Tooling Research and Application Department  
Dr. Viktor P. Astakhov

# Memo

**Re: TTO TC Housing, Operation 10, tool 5 XXXXX end mill  
M5 forming tap issue**

**Figure 1. Chipping on the corner**

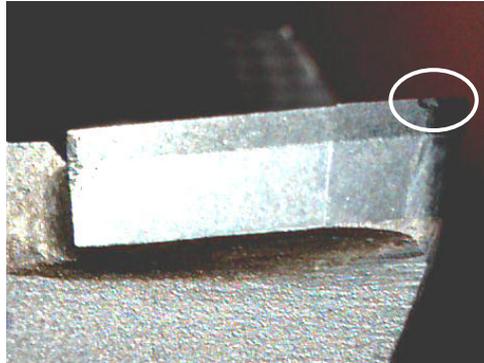
The results of observations the worn tools and machined surfaces have shown that chipping is the most common failure of the inserts brazed on cartridges. There are three areas of chipping: (a) on corners as seen in Figure 1, (b) on the flank surfaces as seen in Figure 2 and (c) on the non-working part of the cutting edge as shown in Figure 3. Moreover, the whole face of the PCD insert is covered by a thin layer of aluminum with the densest area in the center of inserts although there is should not be any contact of the chip in this area under normal cutting conditions.

As additional observation, we would like to prevent your attention to really poor brazing of PCD inserts seen in Figures 1-4. Moreover, in our opinion, there is insufficient flank angle (relief) on the insert that may cause chipping of the flank surfaces. Unfortunately, neither brazing, not relief angles are specified on the cartridge drawing. In our opinion, these information MUST be added to the drawing should it designed to modify XXXXX tools.

**Figure 4. Aluminum deposit on not working parts of the cutting edge**

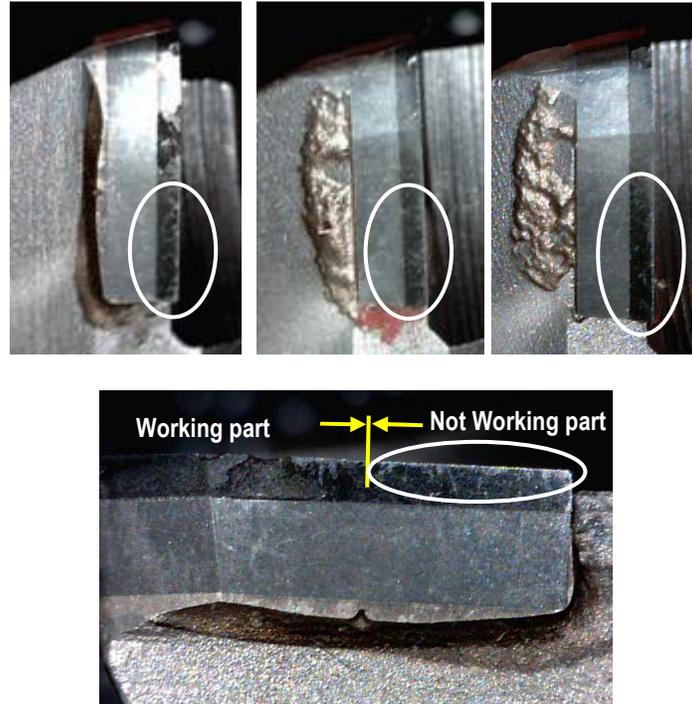
- The side edges of PCD inserts which are not involved in cutting have definite traces of aluminum as clearly seen in Figure 4.
- The chip deflators have heavy chip contact marks.

The root cause of the problem is OBVIOUS: the design and geometry of XXXXX mill cutter is not suitable for the application because the formed chip has no room to escape. The double-positive geometry used for the cartridges directs the formed chip deep into the chip pocket (the explains aluminum deposit on the insert rake faces) where this chip hits the chip deflector (explains the chip marks on the deflector). As the chip pocked is of closed design, the chip tries to squeeze into the narrow gap adjacent to the not working part of the cartridges that explains aluminum deposit on this part (see Fig. 4) and wear marks on the tool body. The hot chip trapped in the chip pocket presents a number of problems as it imposes high pressure (and deflection of the rail) on the PCD inserts causing their significant heating, vibration and re-cutting of the once formed chip.

1. Use a face mill without chip pockets (open cartridge design) as one used at YTO where consistent 15,000 pieces tool life is achieved.
2. Modify the design of XXXXX tool as follows:
  - Use standard XXXXX cartridges with a neutral top rake this should allow chips to flow out the side of the cutter and not be re-cut.
  - Tool geometry. The cutting inserts have a flat cutting edge that generates an excessive heat causing high temperature. Use the following XXXXX standard geometry for these cartridges

- Open chip pockets on the XXXXX mill to allow chip out freely, remove chip deflectors.
- Add an edge prep to the inserts which would strengthen the cutting edge.

**Figure 5. Traces of re-cutting and rail deflection**

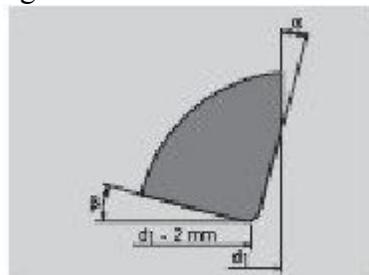
Microscopic observations of the machined surface clearly show (Figure 5) the traces of re-cutting and rail deflections on milling that confirms the root cause.
